Knitex Dresses Ltd.

05 December 2021

Observations

**Torsional irregularity check not included in
the DEA report**

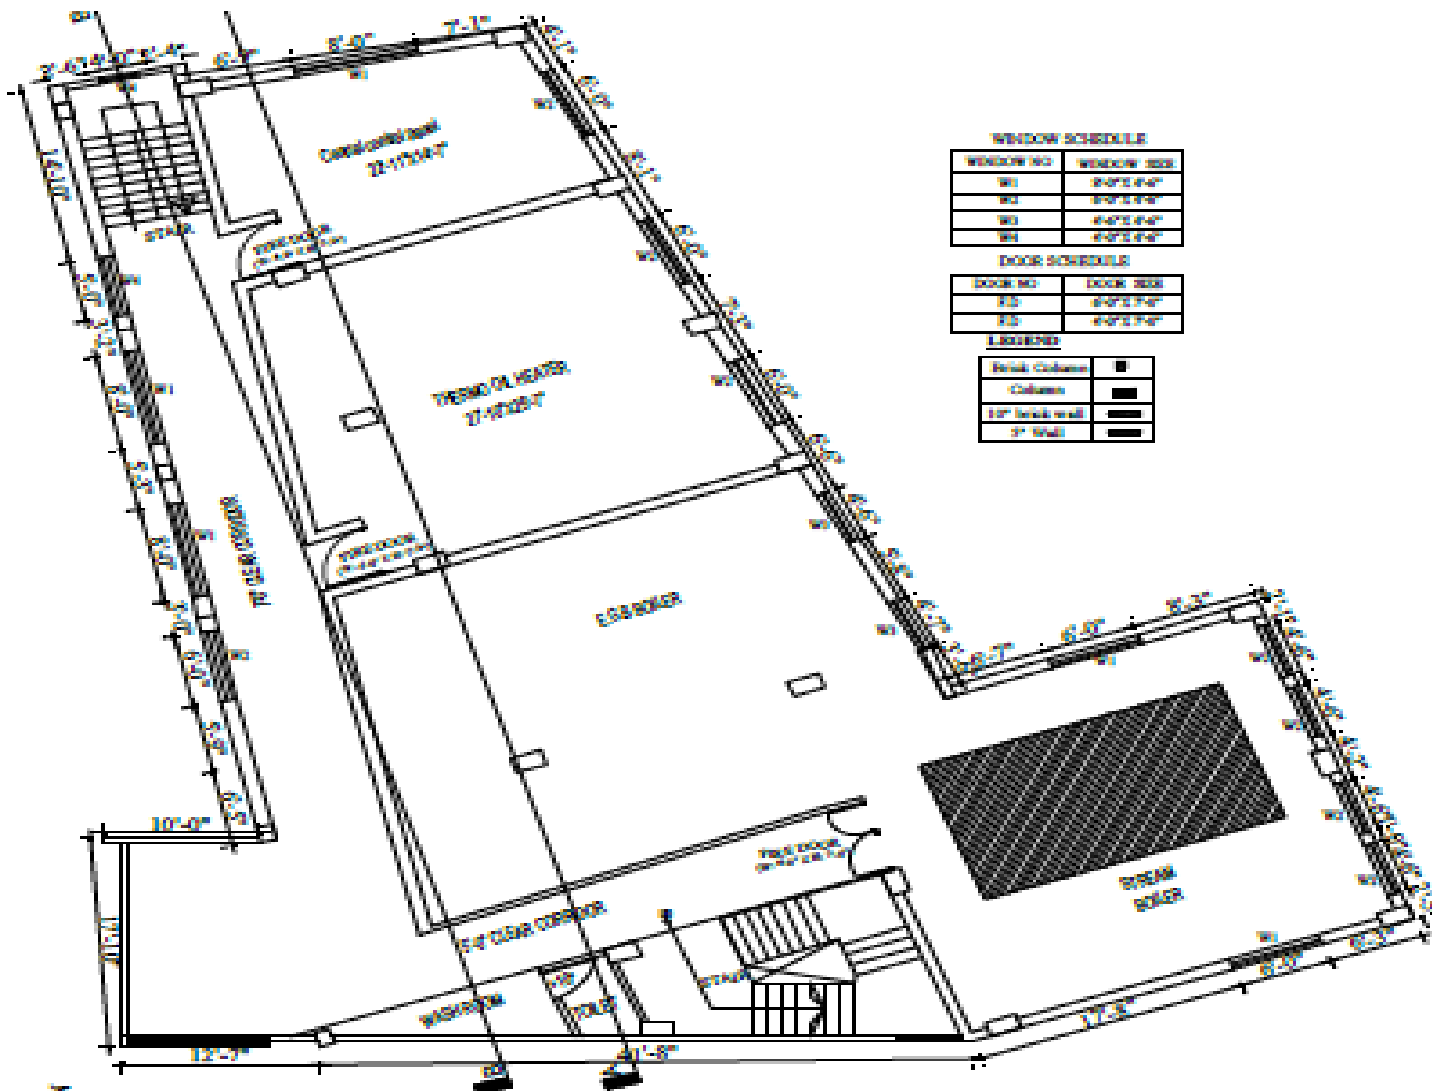
As per building plan, it has an irregular shape which induced torsion into the structure. Building engineer is required to check all type of irregularities & incorporate it in the software-based FEA model & DEA report.

Lack of lateral stability system

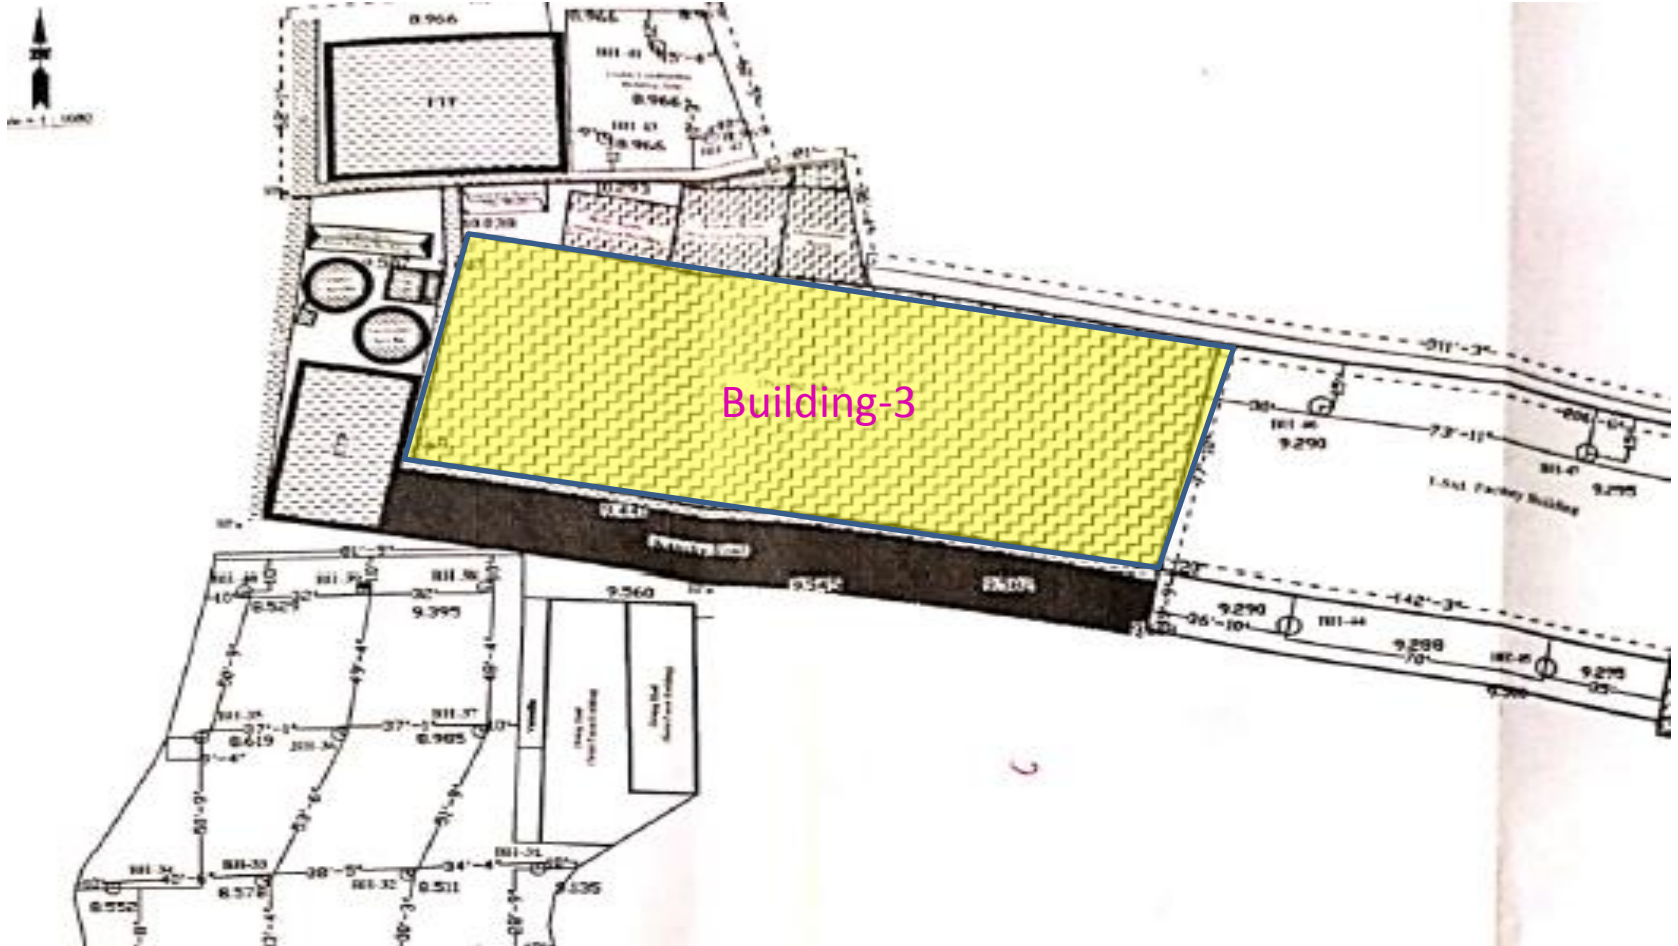
Absence of roof bracing & lateral load transfer media along ridge

Lack of lateral stability system observed at the roof of the shed. Building engineer is required to check the lateral stability of the structure and suggest proper remedial actions accordingly.

Gap between connection plates

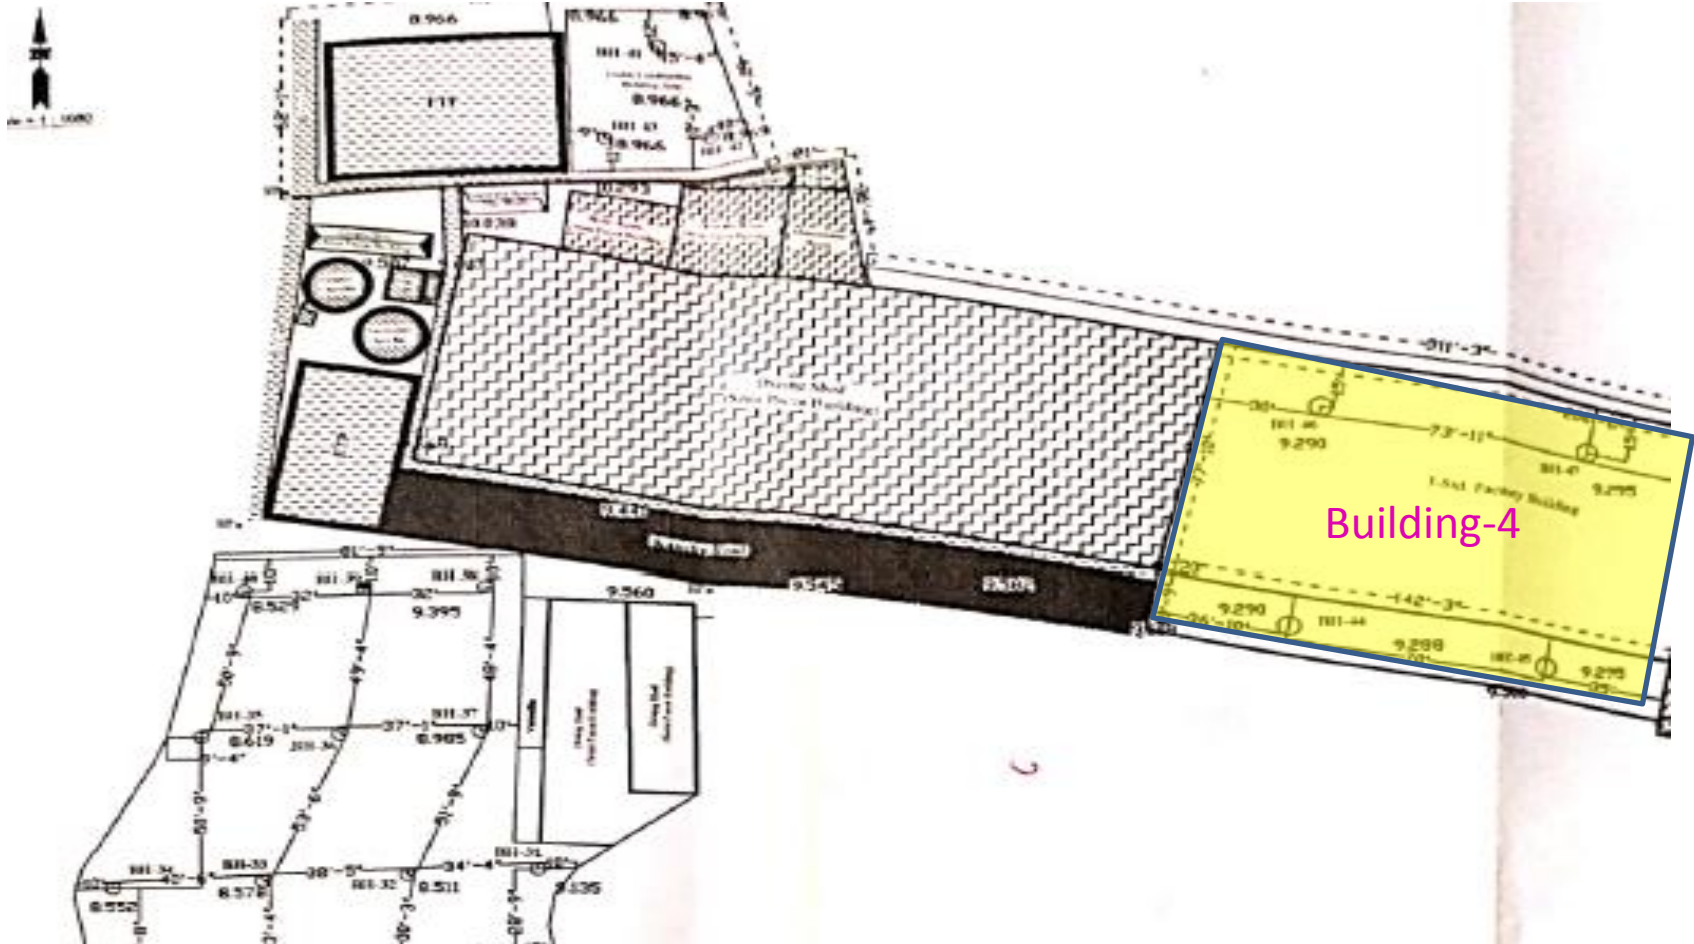
Connection gap at rafter joints

The building engineer is required to fill the connection gaps of all joints.
